Flight Procedures Cover Page	Task Action: FLIGHT CHECK	Task Type: IAP	Estimated Chart Date: 12/02/2021	APWS Task ID: 2EABCD56BEE54850B5038944A009EAFD	APWS Project ID: EF44B95C165C4D8FB523361776CF5220
Procedure: RNAV (GPS)-A ORIG		Enroute: NO	Specialist: Martinelli, Tara		Agreement Number:
Airport ID: 6B9			Airport City: SKANEATELES		State: NY
Facility ID:	Facility Type:	Flight Inspection Remark Type: New FC Slot			
<p>Procedure Comments: VORMON PROJECT: GGT VORMON SCHEDULED FOR DECOMMISSIONING ON 12/02/2021</p> <p>VOR OR GPS-A IS BEING CANCELED, THE RNAV (GPS)-A ORIG AND RNAV (GPS)-B ORIG WILL BE IT'S REPLACEMENT. THE AIRPORT WILL LOSE IFR CAPABILITY WITHOUT THESE APPROACHES. PLEASE ENSURE COORDINATION WITH FPT IF THERE ARE ANY CHANGES.</p> <p>CONTACT DON LANIER: AJV-A431, 405-954-8242.</p> <p>10/22/2021: THIS IS A CORRECTED COPY OF THE FORM APPROVED ON 10/14/2021. FIX MERCC REMOVED AND REPLACED BY FIX ZEMLI.</p>

FIPC BASIC FORM								
PROCEDURE: RNAV (GPS)-A ORIG			AIRPORT NAME: SKANEATELES AERO DROME		AIRPORT ID: K6B9	SPECIAL CONTROL NO: YG-09-149-21		
FAC ID: K6B9A		CITY: SKANEATELES			ST: NY	ORIG CHART DATE: 12/02/2021		
DFL TYPE: PROC/G	THIRD PARTY: <input type="checkbox"/>

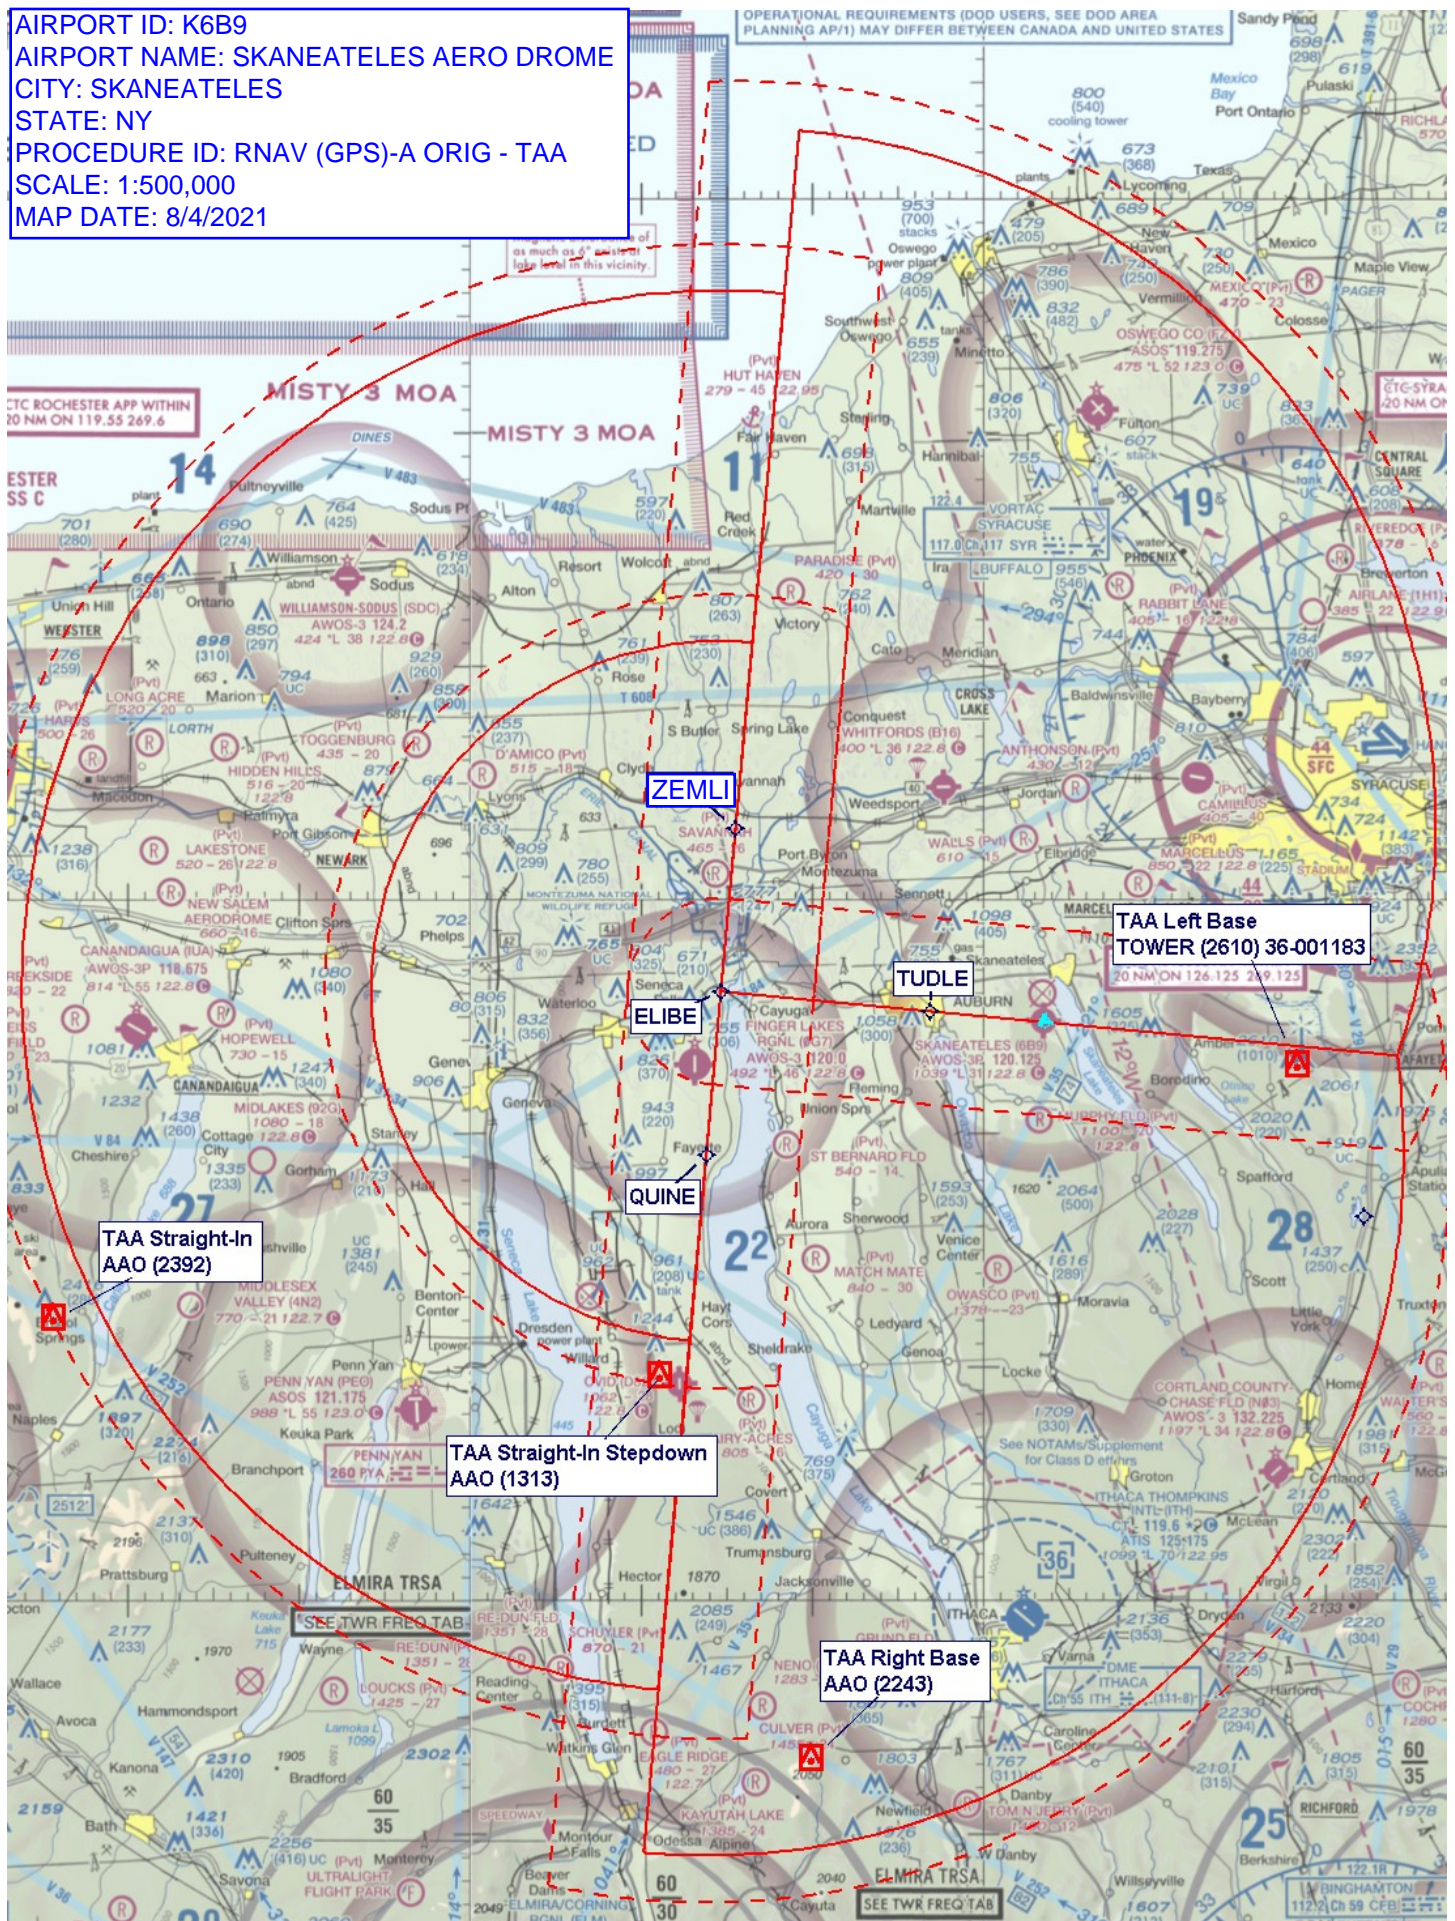
FLIGHT INSPECTOR REMARKS: Recomend the Category A circling minimums should be 1720 MSL to match the RNAV(GPS)-B circling mins due to a 1425 ft MSL,(197 ft AGL) tower located about 1 1/2 miles southeast of the airport. (Tower N42.52.90, W076.25.75).							
IN-FLIGHT OBSTACLE REPORT							
OBSTRUCTION ID #: Tower	COORDINATES OR LOCATION: N42.52.90, W076.25.75	GNSS ALTITUDE (MSL): 1425	BAROMETRIC ALTITUDE (MSL): 1425		HEIGHT ABOVE GROUND LEVEL: 200
